REPORT TO COUNCIL DEVELOPMENT PERMIT & DEVELOPMENT VARIANCE PERMIT

Date: July 11, 2023
To: Council
From: City Manager
Address: 1070-1130 Ellis St
File No.: DP21-0277 & DVP21-0278
Zone: UC1 – Downtown Urban Centre

Section of The Vintage at Waterscapes with Waterscapes Phase 1 to the west

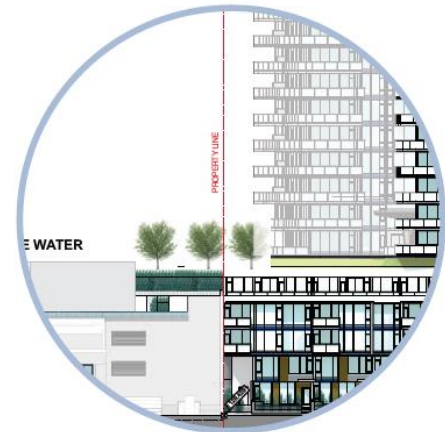
Early in the process, concerns were raised by residents of Waterscapes Phase 1 for how the buildings along the east/west property lines between the two phases would integrate with one another. The applicant responded by wrapping townhomes on the west side of the north podium to create visual interest, setting back the townhomes for greater distance between the two projects, and by utilizing a tiered landscape wall to mitigate any blank parkade walls.

VARIANCE FOR AMENITY FLOORPATE AREA

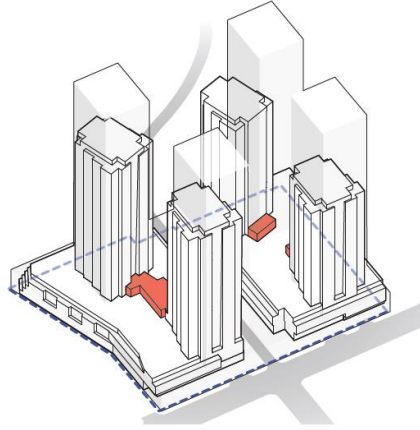
A variance is requested to increase the maximum allowable floor plate for level 6 from 750 square meters to:

- Tower 1 & 2 combined - 1846 square meters
- Tower 3 - 751 square meters
- Tower 4 - 860 square meters

This will allow the design team to provide expanded amenity footprints and greater connectivity between the individual towers.

Additional floorspace on Lvl 6 is fully amenity focused

Added environmental benefits and user convenience

Two variances are requested for the Level 6 amenity floor, an increased floor plate for Level 6 on both podiums and a reduced stepback on the north side between 16.0 m and 16.6 m. These variances are to facilitate the extensive landscape deck and to accommodate a wider range of indoor and outdoor amenity spaces.

SETBACK HEIGHT PROPOSED VARIANCE

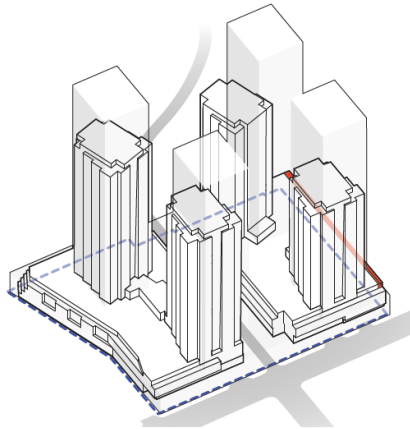
A variance is requested to allow the 4 meter setback at neighboring north properties to occur at 16.6 meters to allow a landscaped amenity deck to be provided for residents.

Any portion of a building above 16.0 m in height must be setback a minimum of 3.0 m from any lot line abutting a street and **4.0 m** from any lot line abutting another property.

Only Parapet is Above Allowable Height Requiring Stepback

Area highlighted in red is the portion of the landscape podium deck that would be lost without variance

VARIANCE FOR STEPBACK AT 16 METERS

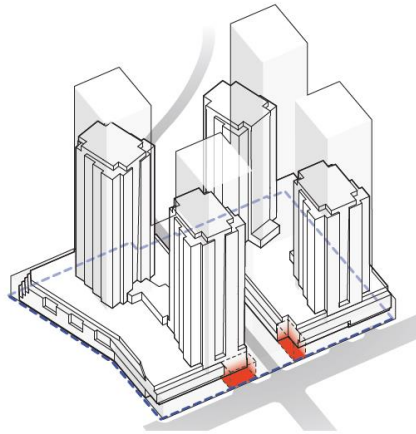
The towers are stepped back from the podium face except for tower two along Ellis St. In order to create the grand residential lobby at grade in this location, the podium and tower is setback 6.0 m, where 0.0 m is required. This allowed the architect to create a strategic dramatic effect by having the tower come to grade flush with the front of the podium. This is a purposeful design consideration to achieve the architect’s vision that triggers the stepback variance. The placement of the tower meets the overall intent of the bylaw regulation which is that towers shall be setback a minimum of 3.0 m from public streets to encourage daylight at at street level.

A variance is proposed to provide a 6 meter setback at grade in lieu of a 3 meter stepback at 16 meters.

Tower setback above podium, including balconies, on the front building facade and flanking building facade (minimum) - **3 meters**

Increased depth of public art plaza impedes 3m setback

A larger plaza does not increase the amount of shading on the public realm

TOWER SEPARATION OF 27 M

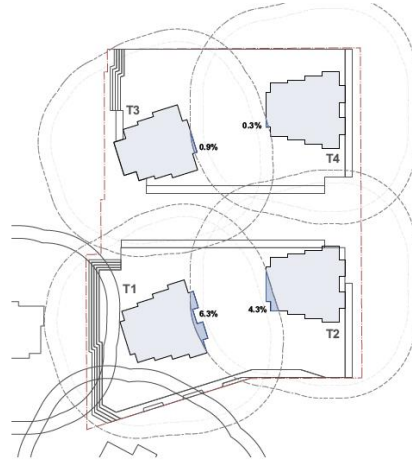
A variance is requested for tower separation between tower one and tower two, and between tower three and tower four from 30.0 m required to 27.0 m proposed (varying). There is no variance requested between tower separation from adjacent properties. Due to the articulated building envelope and irregular balconies, this variance affects only portions of the towers and will have minimal impact on the public realm or adjacent properties in terms of shadows (Attachment D) or privacy.

A variance is requested to provide a minimum tower separation of 27 meters. The project was initiated under the C7 zoning bylaw and was providing tower separation that was greater than the previously acceptable 25 meters.

Minimum Building separation measured from exterior face of the building - **30 meters**
